# Etobicoke Greenway Trail

### Trail alignment changes

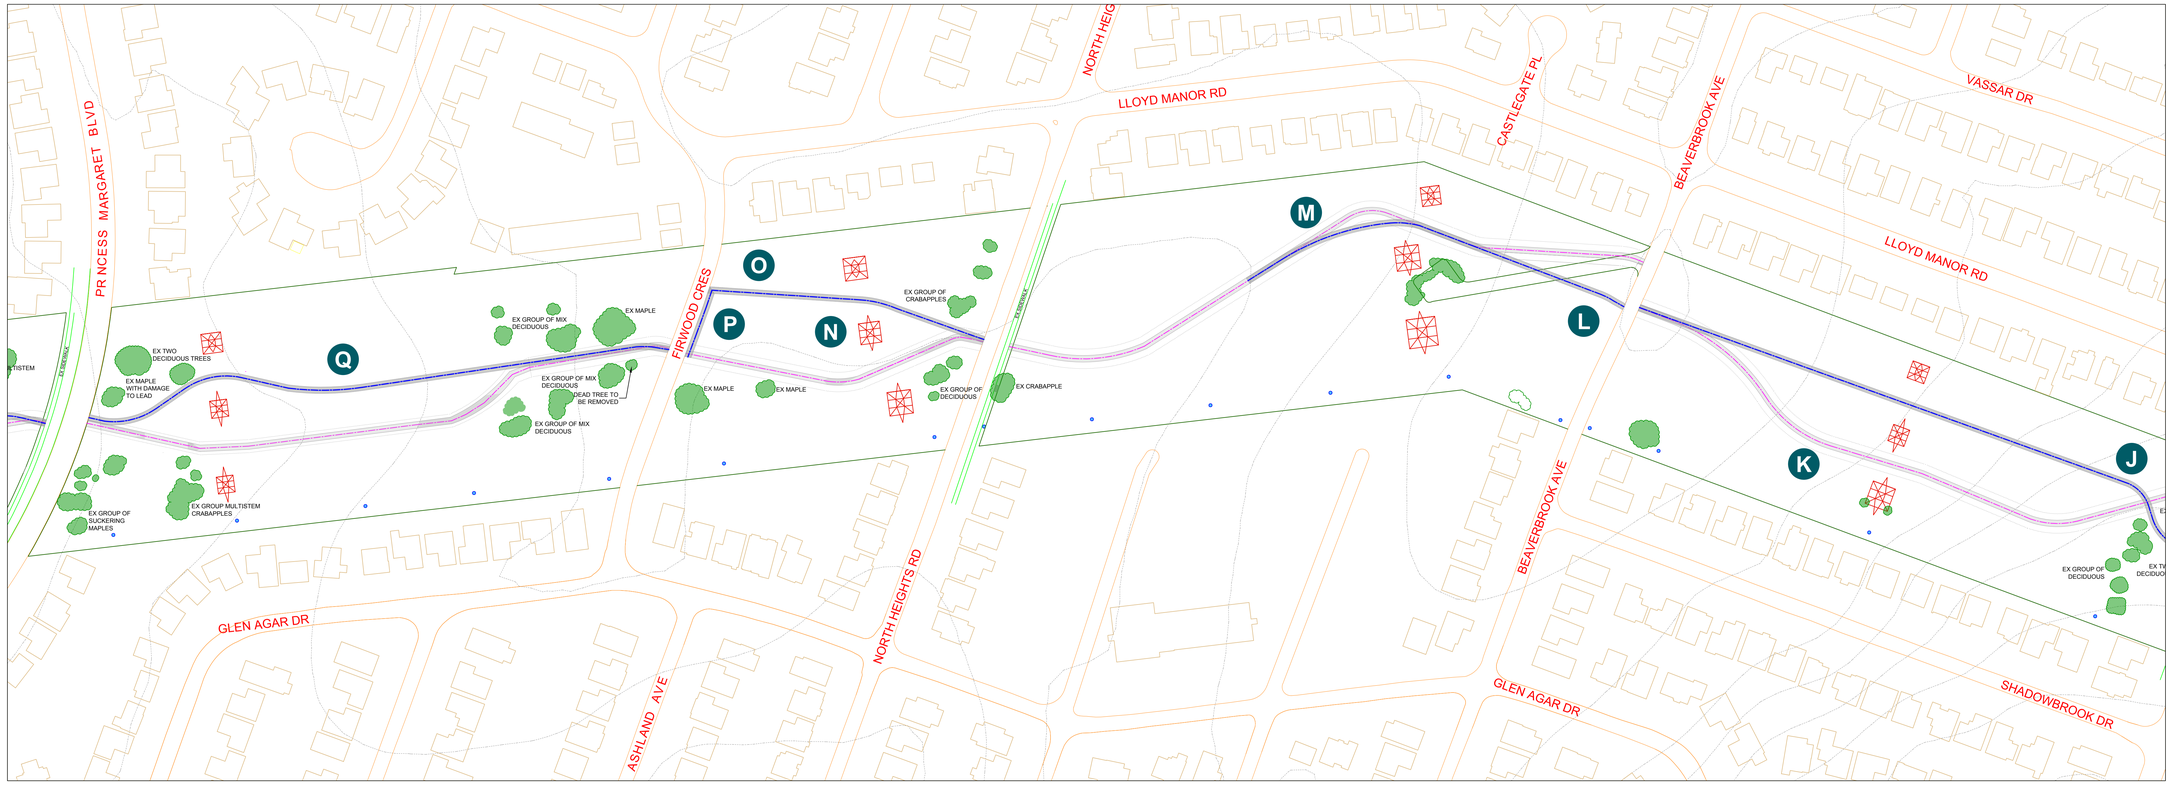
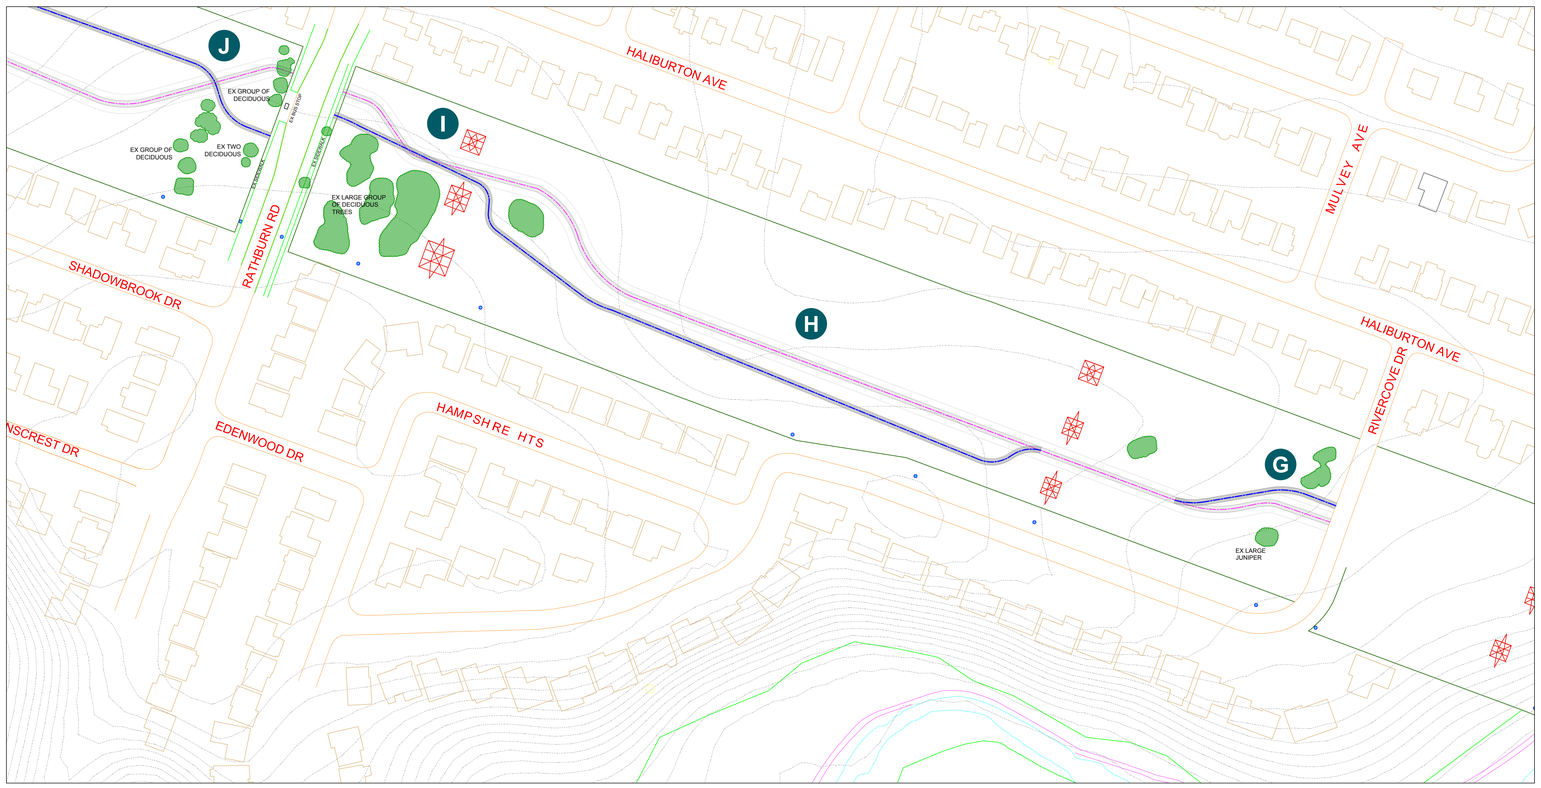
- **G** Align with existing curb-cut access points
- **H** Mitigate drainage impacts and improve accessibility
- **I** Improve alignment of street access points
- **J** Avoid impacts to municipal infrastructure and vegetation
- **K** Mitigate drainage impacts and improve accessibility
- **L** Improve sightlines and alignment of street access points
- **M** Accommodate City standards and mitigate drainage impacts
- **N** Avoid extensive grading requirements
- **O** Avoid steep grades to improve accessibility and safety
- **P** Improve alignment of street access points
- **Q** Improve grading to reduce water pooling for usability and safety
